Battery Cable Mounting Clamp
VN, VHD, VT, VAH

FSB 371-044, Battery Cable Mounting Clamps

(January 2013)

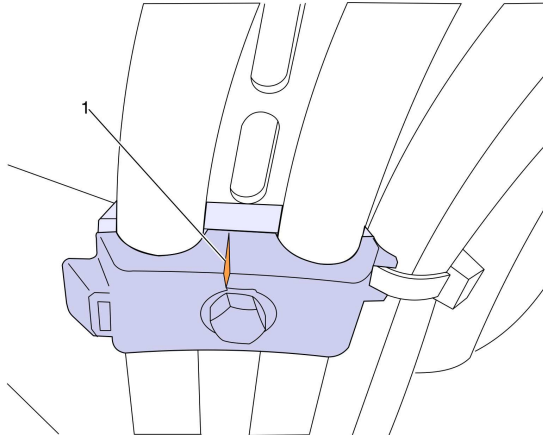
- 1 Secure the vehicle for service by parking it on a flat level surface, applying the parking brake, chocking the rear wheel, and placing the transmission in neutral.
- 2 Inspect battery cable clamps, from battery to starter, to determine how many clamps are cracked or broken.

Note: If no broken clamps are found no further repairs are needed.

W2079310

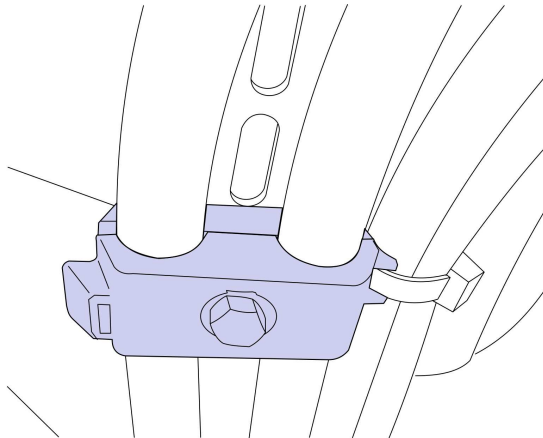
1. Broken or cracked clamp
- 3 Remove the clamp from the bracket mount and cables.
- 4 Install new clamp part # 21658909 onto the cable and secure bracket mounting. Replace cable ties as required.

Torque the nut to: 8.1 ± 1.4 Nm (6 ± 1 ft-lb)

Note: Ensure new clamp is positioned correctly before snapping together otherwise repositioning may be difficult.
